Re: Project No. 1070005-038-AC PSD-FL-380
Modification of the No. 4 Recovery Boiler, No. 4 Lime Kiln and No. 4 Combination Boiler
Response to Request for Additional Information No. 3

**BEST AVAILABLE CONTROL
TECHNOLOGY ANALYSIS
No. 5 POWER BOILER**

Re: Project No. 1070005-038-AC PSD-FL-380
Modification of the No. 4 Recovery Boiler, No. 4 Lime Kiln and No. 4 Combination Boiler
Response to Request for Additional Information No. 3

**FIGURE 1
SIMPLIFIED PROCESS FLOW DIAGRAM FOR
LVHC AND HVLC EXHAUST GASES**

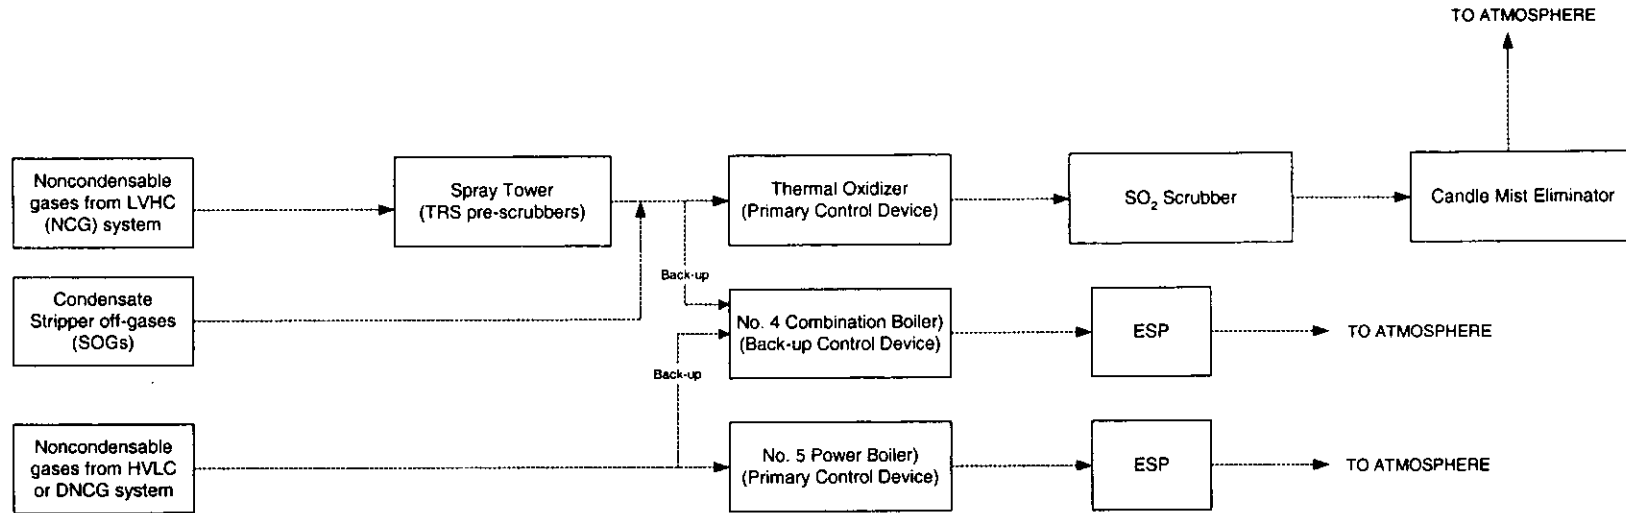
Question: The Department has requested the Mill to provide a simplified process flow diagram (PFD) indicating the primary and back-up control devices used to control emissions from the facility’s waste gas streams.

Answer: A simplified PFD has been prepared and is attached as Figure 1.
